MONTGOMERY COUNTY HISTORIC PRESERVATION COMMISSION
STAFF REPORT

Address:	17 Magnolia Parkway, Chevy Chase	Meeting Date:	6/23/2021
Resource:	Contributing Resource (Chevy Chase Village Historic District)	Report Date:	6/16/2021
Applicant:	Ben and Kristine Gielow	Public Notice:	6/9/2021
Review:	HAWP	Tax Credit:	No
Permit Number:	953674	Staff:	Michael Kyne
PROPOSAL:	Rear porch enclosure

Fig. 1: Subject property.

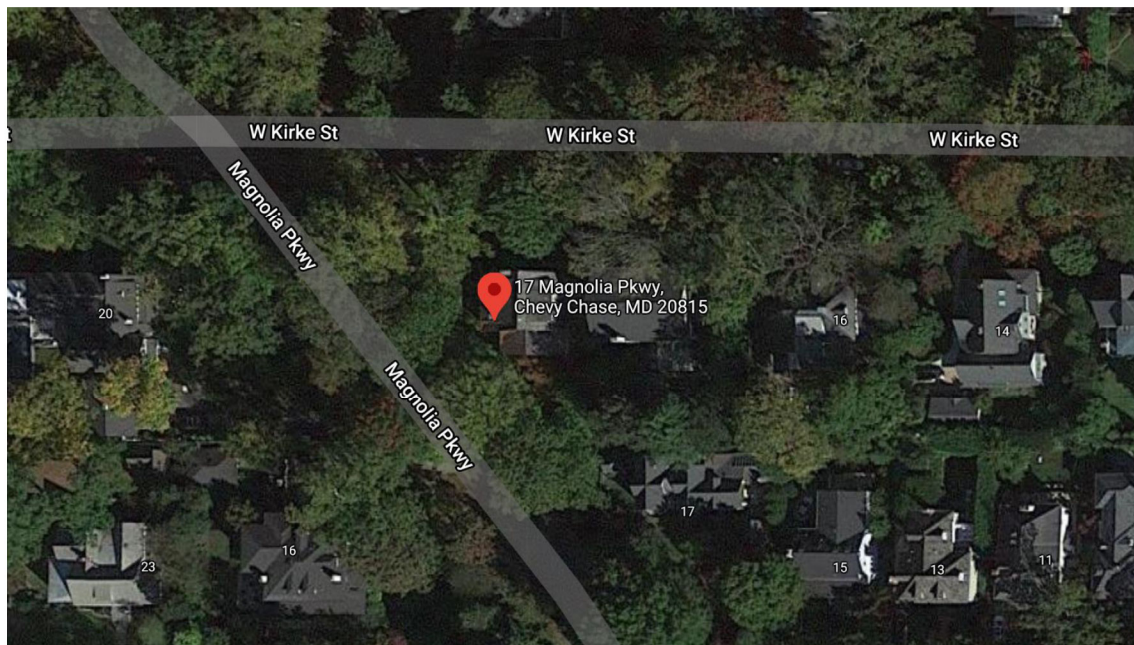
Due to the property's location on a corner lot, staff finds that the proposed alterations will be partially visible from the public rights-of-way of both Magnolia Parkway and West Kirke Street. Accordingly, the proposal should be reviewed with moderate scrutiny. The *Guidelines* define moderate scrutiny as "... a higher standard of review than 'lenient scrutiny.' Besides issues of massing, scale and compatibility, preserving the integrity of the resource is taken into account. Alterations should be designed so that the altered structure still contributes to the district. Use of compatible new materials, rather than the original building materials, should be permitted. Planned changes should be compatible with the structure's existing design, but should not be required to replicate its architectural style."

Staff supports the proposed rear porch enclosure, finding it consistent with the *Guidelines*. The porch to be enclosed is at the rear, and it is generally compatible with the style and materials of the historic house. As stated in the *Guidelines*, rear porch enclosures have occurred throughout the historic district "... with

little or no adverse impact on its character, and they should be permitted where compatibly designed.” Staff also finds that the proposed windows will be constructed from compatible new materials, consistent with the *Guidelines* and statement regarding moderate scrutiny.

Staff recommends that the Commission **approve** the HAWP application under the Criteria for Issuance in Chapter 24A-8(b) (1), (2), and (d), having found that the proposal is consistent with the *Chevy Chase Village Historic District Guidelines* identified above, and therefore will not substantially alter the exterior features of the historic resource and is compatible in character with the district and the purposes of Chapter 24A;
